06-324r5 SAS-2 Modifications to the SAS Speed Negotiation

To: T10 Technical Committee  
From: Amr Wassal, PMC-Sierra (amr\_wassal@pmc-sierra.com)  
Stephen Finch, STMicroelectronics (steve.finch@st.com)  
Date: 20 September 2006  
Subject: 06-324r3 SAS-2 Modifications to the SAS Speed Negotiation

Revision 3 (20 September 2006) Updates based on 12 September 2006 Phy Working Group meeting. A significant re-organization, plus many changes to make consistent use of new terms like Final-SNW and Train-SNW. Updates to diagrams.

**Figure 122 — SAS SNW-1, SNW-2 and Final-SNW**

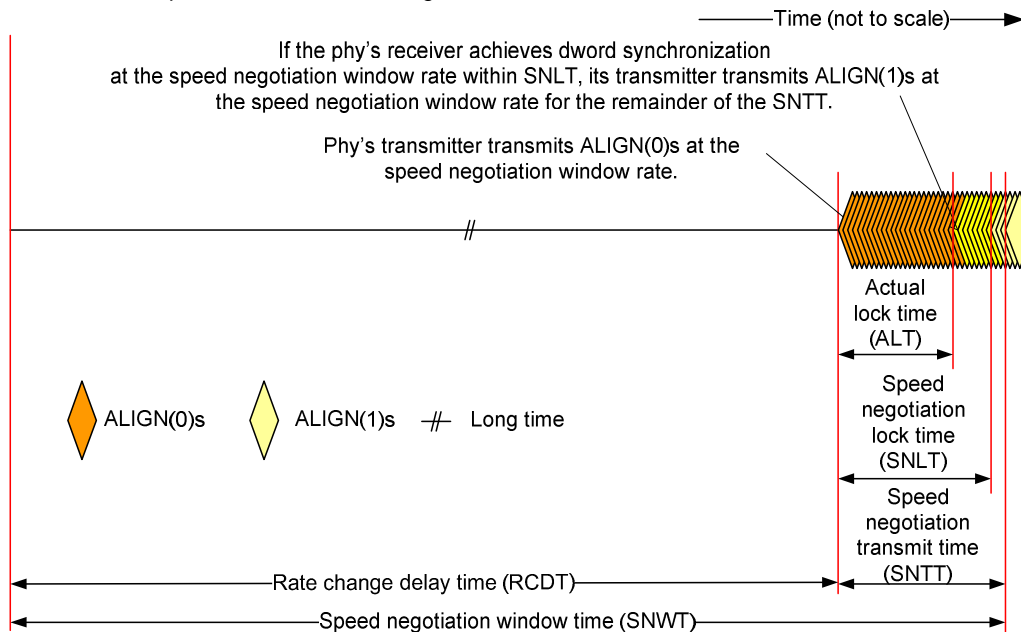
<<Rev 5 added periods to sentences in figure 122>>

Figure 123 — SAS SNW-3

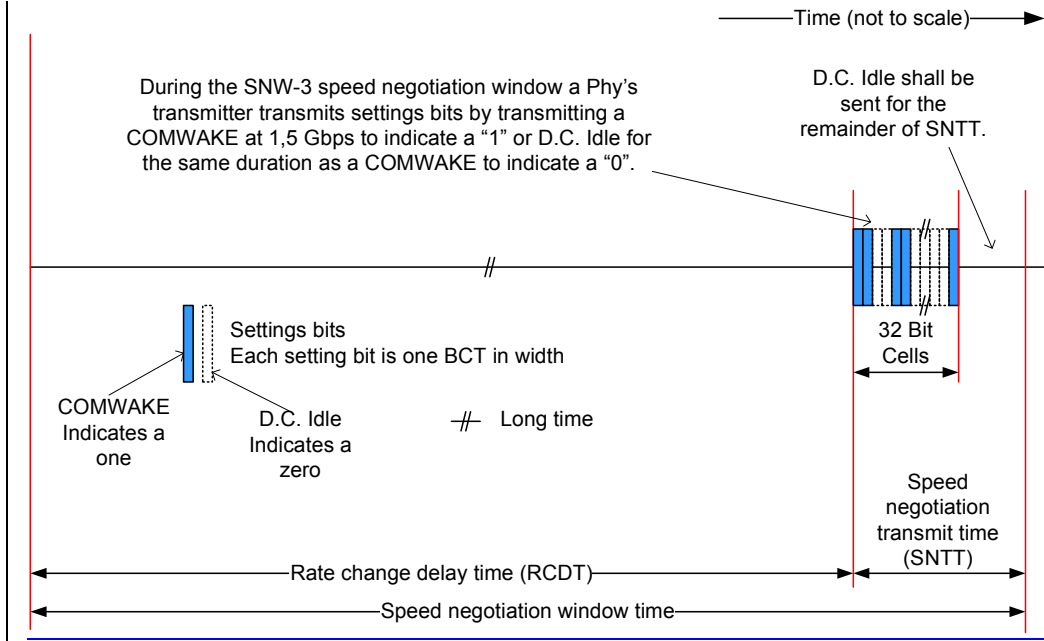
<Rev 5 added periods at the end of sentences, removed periods from discriptors, and changed "1" and "0" to one and zero in figure 123.>

Figure 124 — SAS Train-SNW

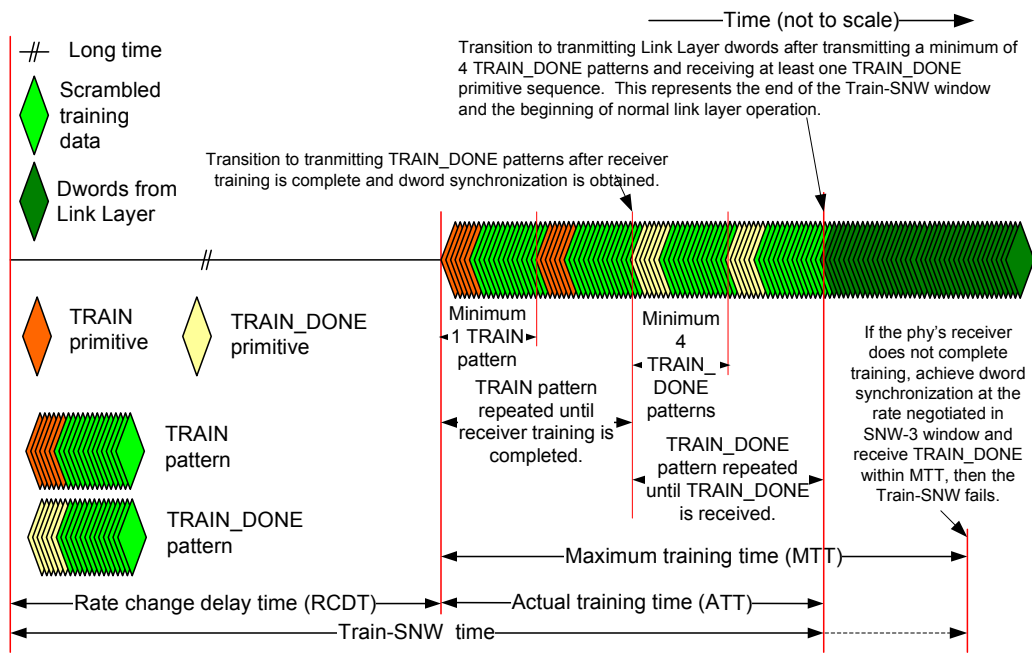
<<The phy working group conference call had started, but not completed, the review of 6.7.4.2.3.3 during the 9/28/06 conference call. Some changes were made to this section but more are likely.>>

<Rev 5 added periods at the end of sentences, removed periods from discriptors in figure 124.>

Figure 126 – SAS Final-SNW phy reset problem

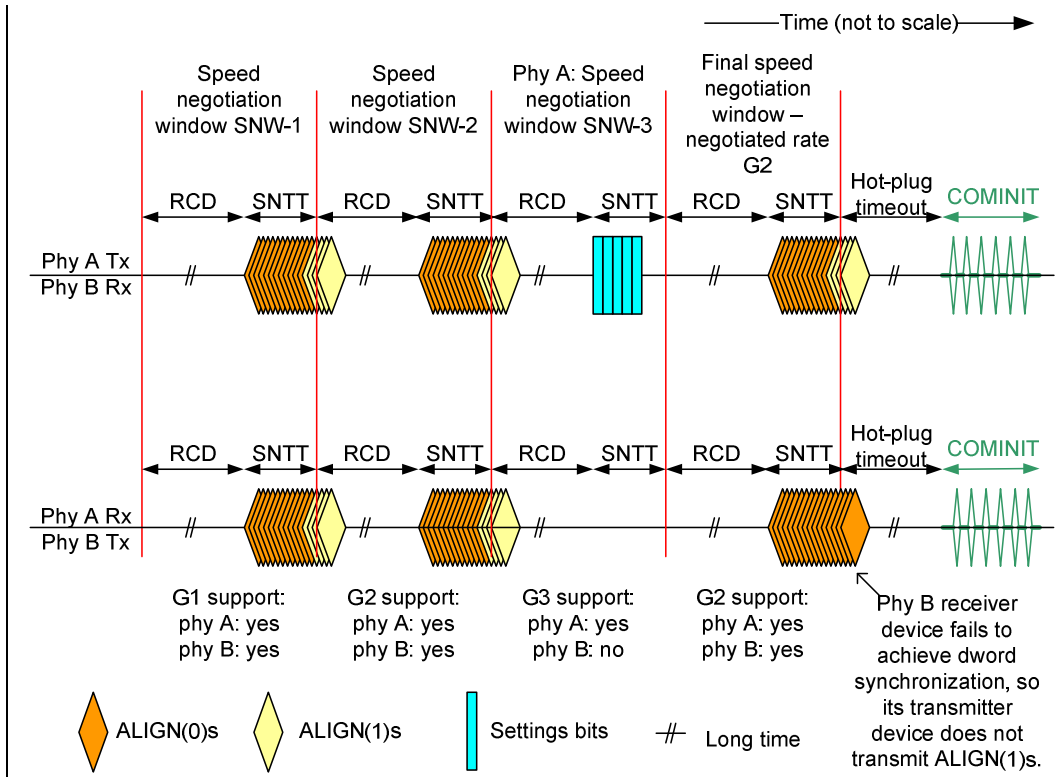
<Rev 5 added periods at the end of sentences, removed periods from discriptors in figure 126.>
